MONTGOMERY COUNTY HISTORIC PRESERVATION COMMISSION
STAFF REPORT

Address:	7124 Willow Avenue, Takoma Park	Meeting Date:	3/25/2026
Resource:	Outstanding Resource Takoma Park Historic District	Report Date:	3/18/2026
Applicant:	David Zelinsky and Dorothy Lee (Rick Leonard, Agent)	Public Notice:	3/11/2026
Review:	HAWP	Tax Credit:	Partial
Permit No.:	1150526	Staff:	Laura DiPasquale
Proposal:	<u>Porch alterations</u> , hardscape alterations and handrail installation

Figure 2: Existing front elevation photo, left (March 2025, Historic Preservation Division); and proposed site plan, right.

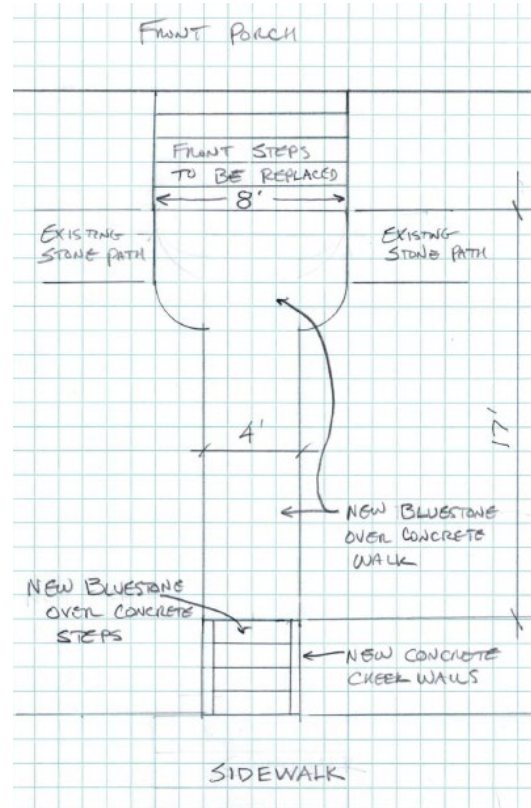
Staff supports the proposed hardscape alterations and recommends approval. Staff finds that the existing concrete steps and walkway are not original to the construction of the house and that its replacement does not constitute removal of historic fabric or substantially alter the exterior features of the resource, per *Standards* 2 and 9 and Chapter 24A-8(b)(1). Staff further finds that the proposed bluestone paving is compatible with the historic resource, per *Standard* 9 and Chapter 24A-8(b)(2). In addition to the paving replacement, the applicants propose to install a round metal handrail along the steps leading from the walkway to the sidewalk. Staff finds that this work likewise will not have a substantial impact on the resource and is compatible with the character of the property and district, per *Standard* 9 and Chapter 24A-8(b)(1) and (2).

Figure 6: Proposed plan sketch showing the newel post location relative to the bottom step.

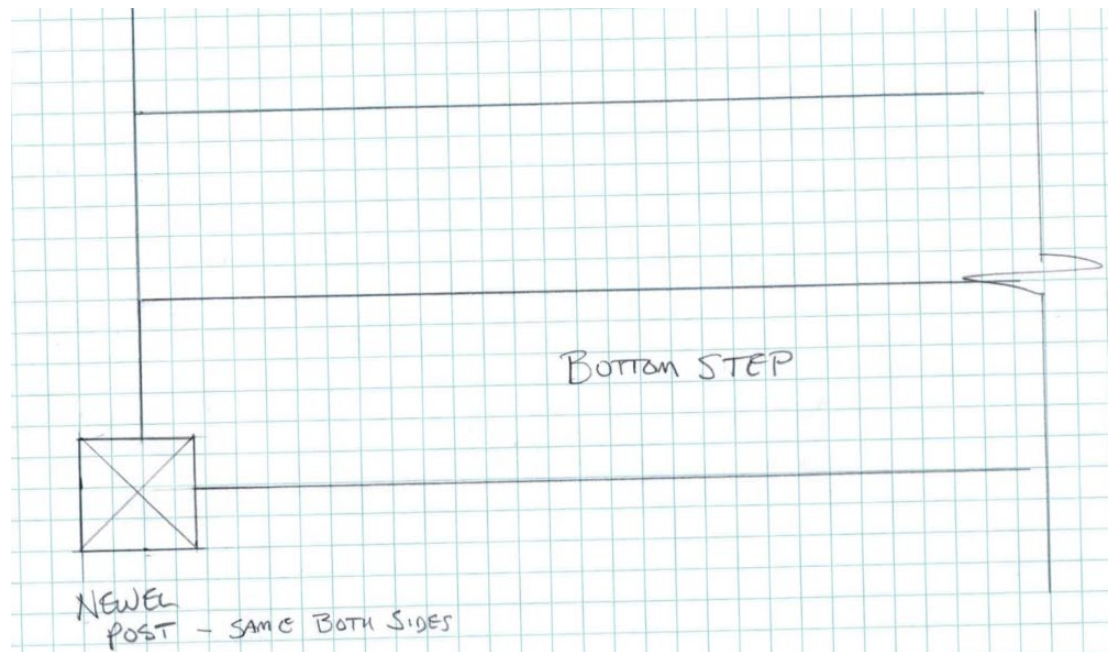
Staff supports the proposed porch alterations and recommends approval. Staff notes that the original scope of work included replacement of the risers with Boral, but that the applicants have agreed to Sapele wood, in keeping with the HPC's Policy 24-01, which identifies wood as the appropriate material for porch and deck replacement on Outstanding resources. Staff finds that the railing replacement will largely be in-kind, with new top and bottom rails and square balusters to match existing, but that the proposed newel posts will slightly differ from the existing. With the first concrete step removed, the newel posts will be slightly longer than the existing newel posts, extending to grade rather than terminating on the top of the first step. The proposed caps are also slightly different from the existing tiered caps, with a wider pyramidal shape. Staff finds that the proposed scope does not remove historic materials that characterize the property and is compatible with the resource, per *Standards 2 and 9*, and Chapter 24A-8(b)(1) and (2). Staff notes that this portion of the scope is eligible for the County's historic preservation tax credit.
